Attachment 1:
Amendment to BAW-1432
Oconee 3, Cycle 2
Reload Report
October 20, 1976

Attachment 2:
Proposed Revisions to Oconee Nuclear Station
Technical Specifications
October 20, 1976

Re: Oconee Unit 3
Docket No. 50-287

AMENDMENT TO BAW-1432

Figure 1. Core Loading Diagram for Oconee 3, Cycle 2.

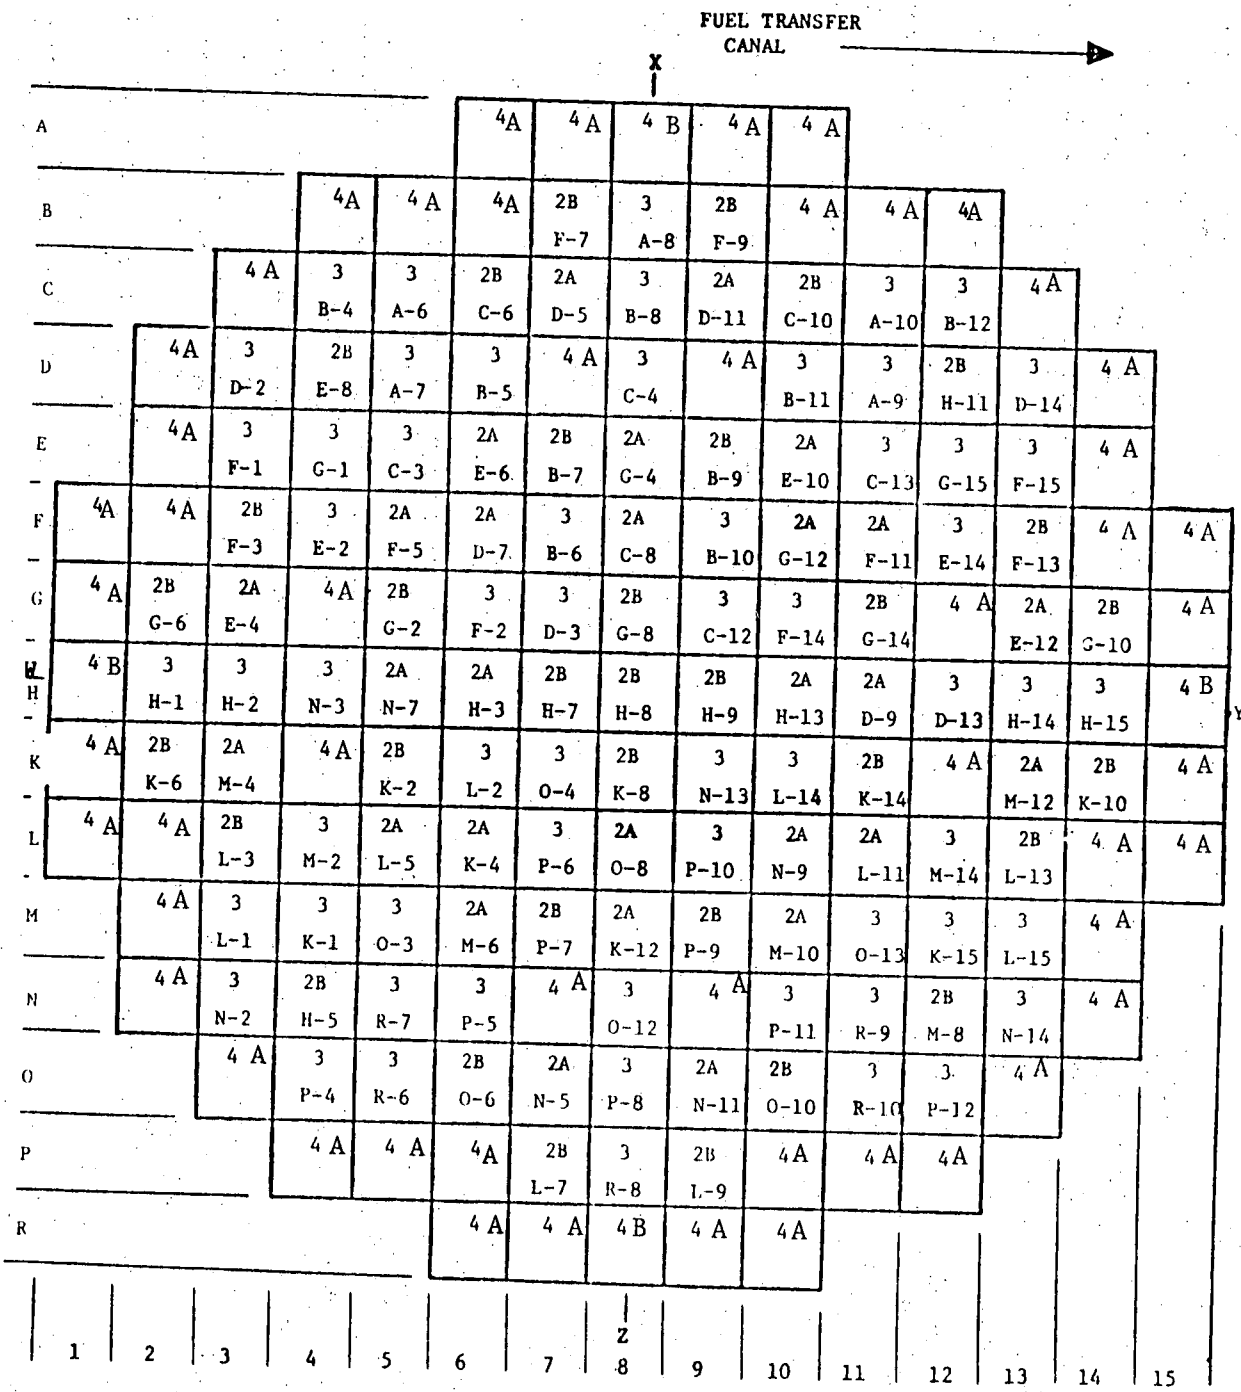
This report amends the Oconee Unit 3, Cycle 2 Reload Report BAW-1432 dated June, 1976 to account for modifications to the core loading plan. The revised core loading plan for Oconee Unit 3, Cycle 2 will have four 2.64 wt % uranium-235 Mark B fuel assemblies replacing four 2.53 wt % uranium 235 Mark B fuel assemblies originally intended to be inserted in Cycle 2.

Figure 1 is the revised core loading diagram for Oconee 3, Cycle 2. The initial enrichments of batches 2A, 2B, and 3 were 2.60, 2.67, and 3.00 wt % uranium-235, respectively. Batch 4A contains 52 fuel assemblies enriched to 2.53 wt % uranium-235 and batch 4B contains four fuel assemblies enriched to 2.64 wt % uranium-235. The nominal fuel assembly loadings are 463.6 kg of uranium for Batches 2A, 2B, 3 and 4A and 468.25 kg of uranium for Batch 4B. Figure 2 is an eighth-core map showing the assembly burnup and enrichment distribution at the beginning of Cycle 2. Control rod group designations are the same as shown in BAW-1432.

Figure 4. Oconee 3, Cycle 2 - Rod Position Limits for Four-Pump Operation From 115 (± 10) EFPD to 226 (± 10) EFPD

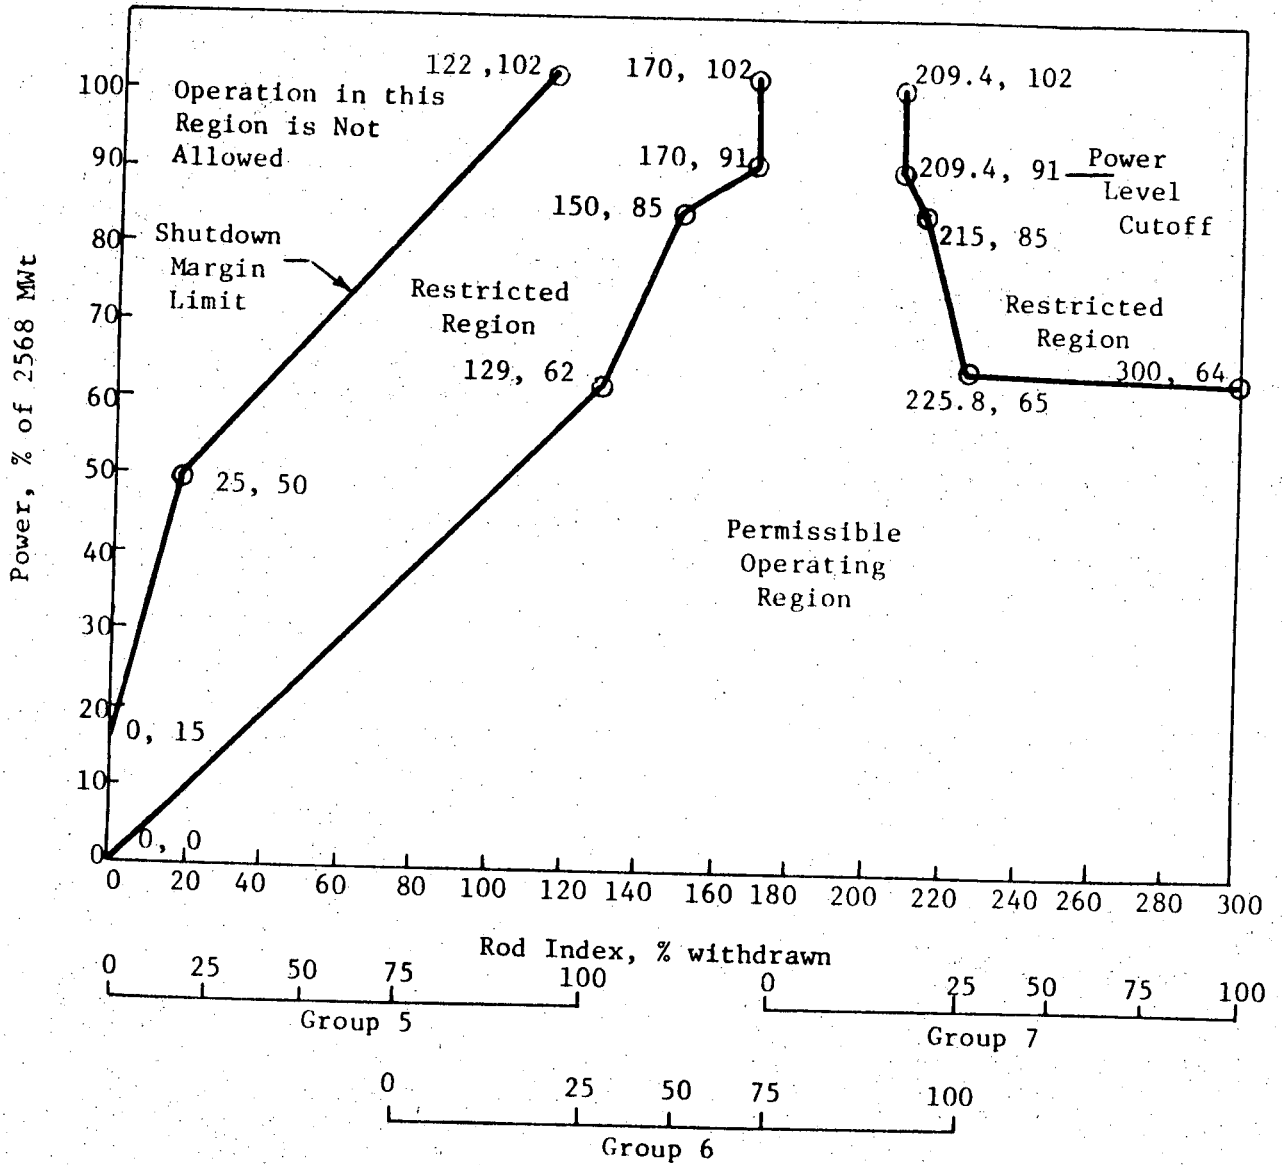
The revised loading plan will not affect the technical specifications from BOC to 115 EFPD and will not affect the limiting conditions for operation at power throughout the cycle. However, after 115 EFPD, the rod position limits for shutdown margin must be modified to account for the minor changes in rod worth. The limiting condition for operation at power is determined by the LOCA kw/ft rod position limits and not the shutdown margin rod position limits. Changes to the shutdown margin rod position limits are presented in Figures 4, 5, 6, and 7.

ROD POSITION LIMITS FOR FOUR PUMP OPERATION FROM 115 (+ 10) EFPD TO 226 (+ 10) EFPD UNIT 3

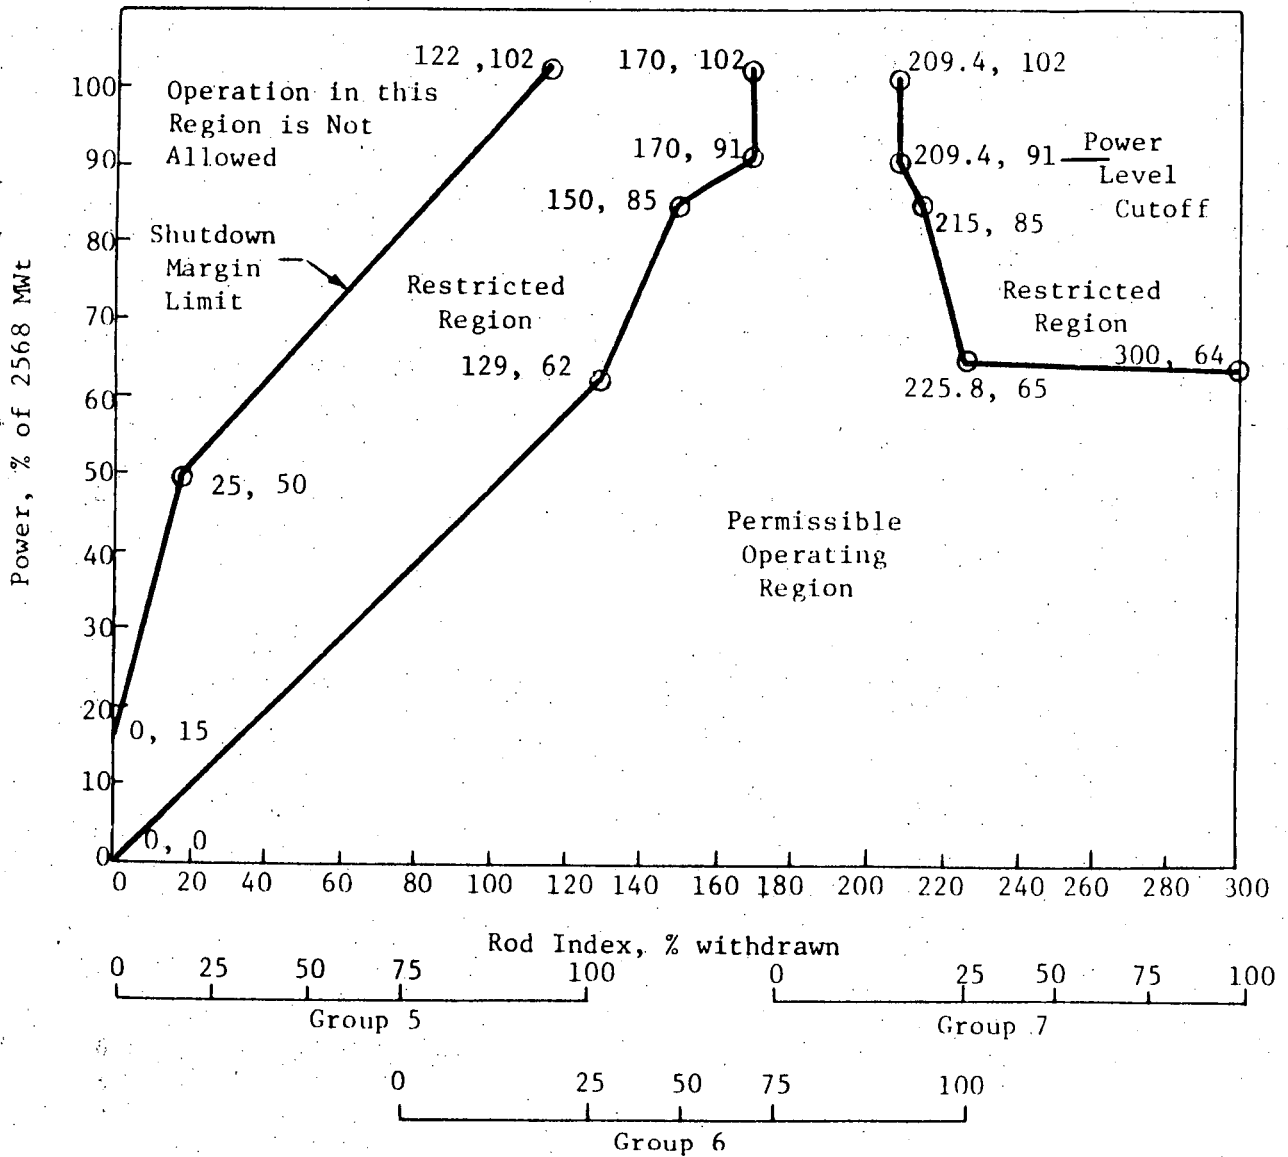
Pursuant to 10CFR50, §50.90 proposed changes to the Oconee Nuclear Station Technical Specifications are requested which will provide for the operation of Oconee Unit 3, Cycle 2 with the above changes. These revisions are incorporated in the revised figures shown in Attachment 2.
